CONDITIONS OF APPROVAL:

Engineering - Final Plat Checklist

2. 0. General Information

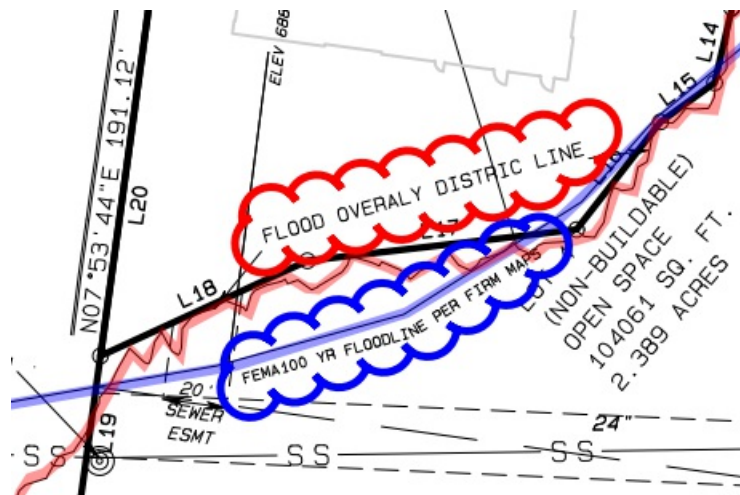
joe.marlo@franklinton.gov Comment to remain open while Site Plan is still under review

Applicant shall ensure that any modifications to the site plan (COF 6579), which is being reviewed concurrently with this final plat, are reflected on the final plat. The final plat shall match the site plan.

6. C. Final Plat

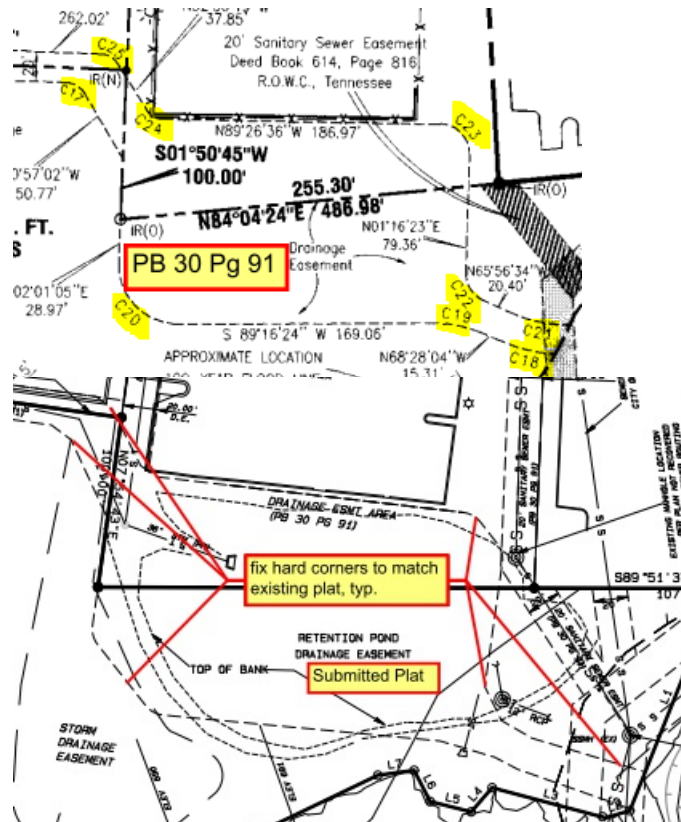
Applicant to show the proposed sidewalk at Rosa Helm Way on the plat, and revise the public access easement for the sidewalk to encompass the revised pedestrian crossing at Rosa Helm Way.

Note specifically the following:

1. The "5' Public Access Esmt (P.A.E.)" note is to be revised to state "Public Access Esmt (P.A.E.)" (without "5' ") and show easement dimensions on the plat, as the easement is more than 5 feet at multiple locations.
